UNITED STATES PATENT AND TRADEMARK OFFICE

Office Action Summary	Application No. 10/511,405	Applicant(s) WEISNER ET AL.	
	Examiner MICHAEL MASKELL	Art Unit 2881

DETAILED ACTION

Regarding claim 1, the applicant's arguments indicate that there appears to still be some confusion as to exactly what component of Strecker's Fig. 7 the examiner is regarding as the spacer. Below is an excerpt from Fig. 7 of Strecker, in which the

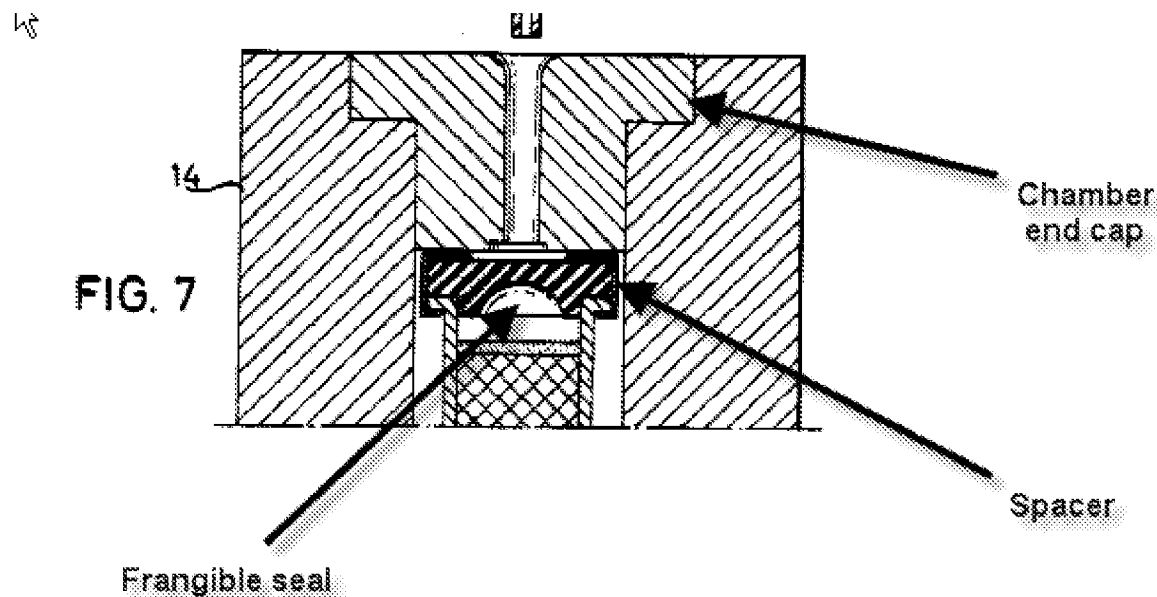
examiner has labeled the spacer.

3. As can be seen above, the examiner's interpretation of Fig. 7 includes a spacer that is in contact with both the isotope generator and the end of the shielded chamber, thus functioning as a spacer. In use, Strecker's needle pierces both this spacer and the seal of the isotope generator, causing the spacer to surround the needle. Strecker indicates that "the junctions of nuclide generator 13 are provided with piercable stoppers made of an elastic material." This, in combination with Fig. 7 above, indicates that these stoppers provide both a compressible buffer and spacing.
